redland oaks

REDLAND - BULVERDE JOINT VENTURE MASTER PLAN

RE: Redland Oaks Development Plan #207

Re: Redland-Bulverde Joint Venture

preliminary plan

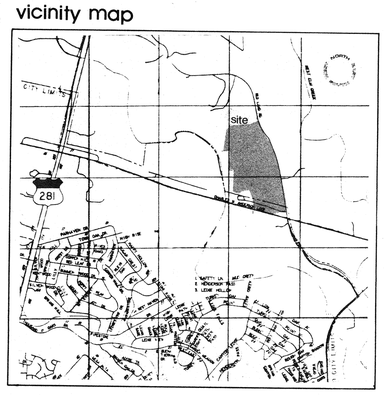
Redland Road is a Secondary Arterial Type "A", 86' R.O.W. on the Major Thoroughfare Plan. Provisions for proper street dedication is requested. Please revise your plan accordingly.

(XX) Comments: It is recommended that the planned entry street (86' R.O.W.) at F.M. 1604 be coordinated with the Texas State Department of Highways and Public Transportation. The purpose is to preclude any conflict with possible projected highway plans.

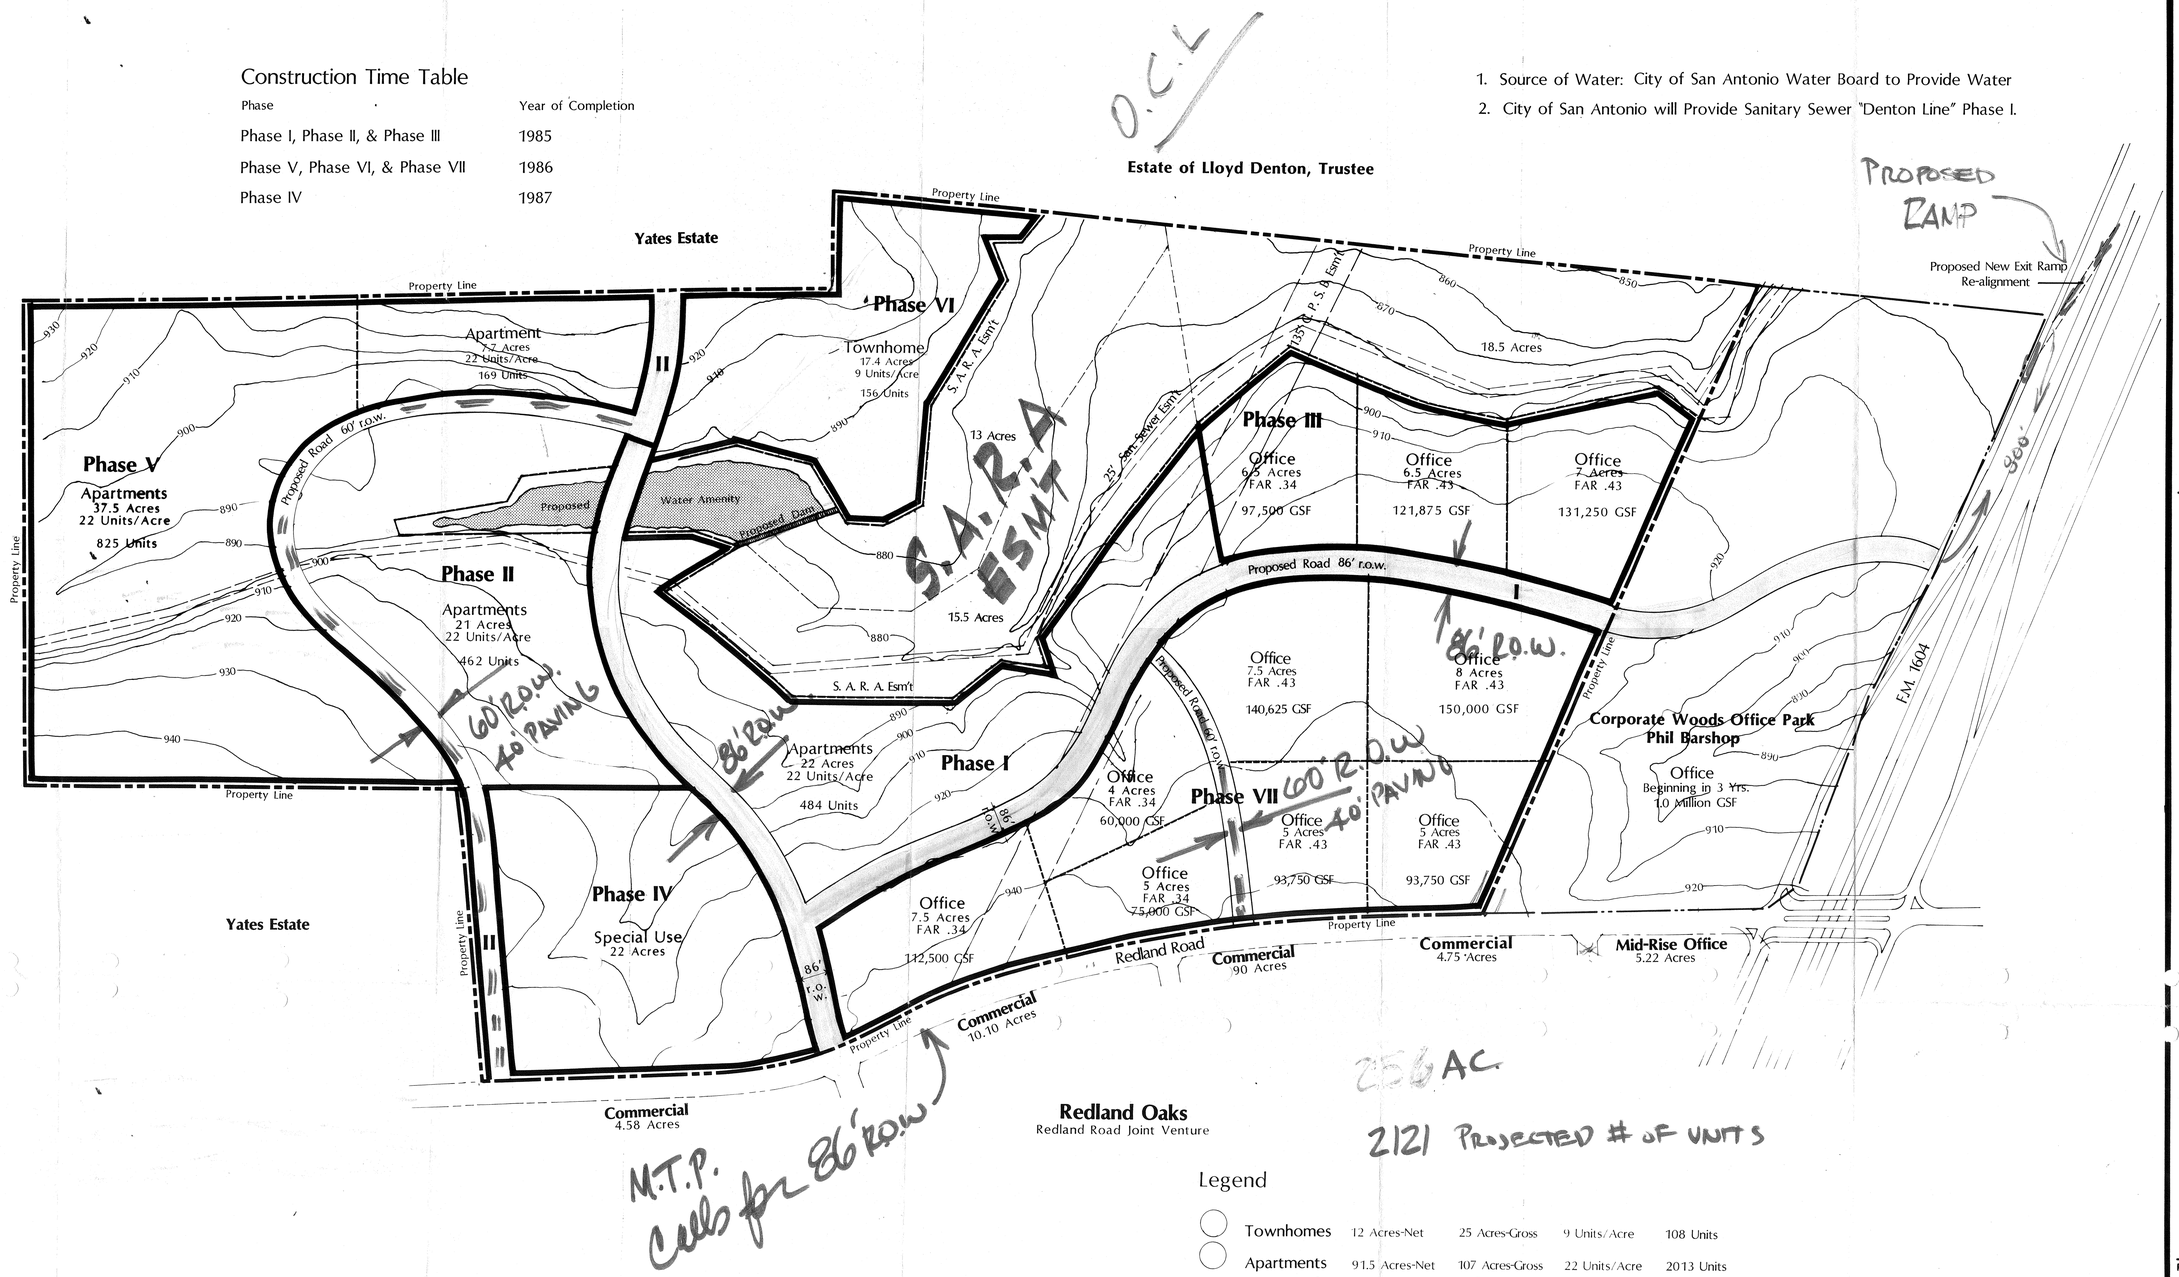
(X) Comments: This is to advise you that the POADP bordering the southern property line of your development project has been amended to delete the 60' R.O.W. referenced in our comments dated January 30, 1985. In view of this, staff offers no objections to your plan as submitted.

It is noted that the POADP bordering the southern property line of your scheme is not consistent with your proposal. The development plan (Corporate Woods Office Park) calls for a 60' R.O.W. linking the north-south 86' facility with Redland Road. In addition, the street as depicted encroaches into the Pargon property. Taking this into account, it is recommended that planning efforts be coordinated with neighborhing property owners. Once this matter has been resolved, please make the necessary changes to the POADP and resubmit the plan for staff review.

(X) Comments: It is noted that the POADP bordering the southern PL of your scheme is not consistent with your proposal. The development plan (Corporate Woods Office Park) calls for a 60' ROW linking the north-south 86' facility with Redland Rd. The street as depicted encroaches onto the Parson property. Taking this into account, it is recommended that planning efforts be coordinated with neighboring property owners. Once this matter has been resolved please make the necessary changes to the POADP and resubmit the plan for staff review.
